SVE BULLETIN

QVM BULLETIN: Q-323 DATE: 11 / Aug, 2020

Super-Duty Max-Width Exterior Mirrors (for 102” Upfit Bodies)

MODEL(S) AFFECTED:
2017 – 2022 Super-Duty (Chassis Cab Only) – Order Guide Code 54L
2015 – 2020 F-150 (retrofit only, depending on original-build mirror type)

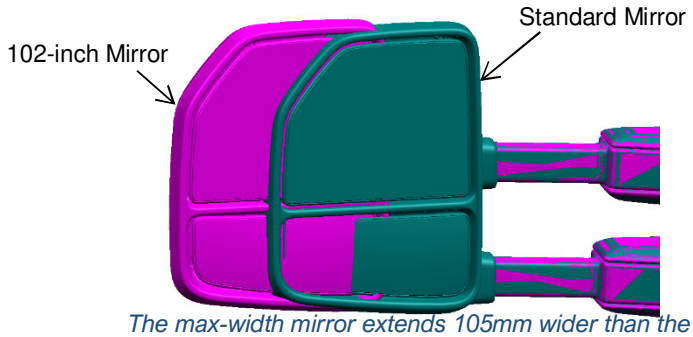
ISSUE / DESCRIPTION:
Maximum-width exterior mirrors are now available on Super-Duty chassis cab trucks (limited to Regular Cab only). These mirrors provide extended visibility beyond that provided by the current standard-width exterior mirrors, making them ideal for upfit bodies up to 102” wide. These 102” mirrors can be retrofitted onto Super-Duty trucks back through MY2017. They may also be retrofitted onto some F-150 trucks MY2015 – 2020 (where compatible with the harness of the vehicle’s original mirror content) – an adapter harness may be required (service part # JL3Z – 14A411 – B*).

The max-width mirror extends 105mm wider than the standard Super-Duty mirror (both fully extended).
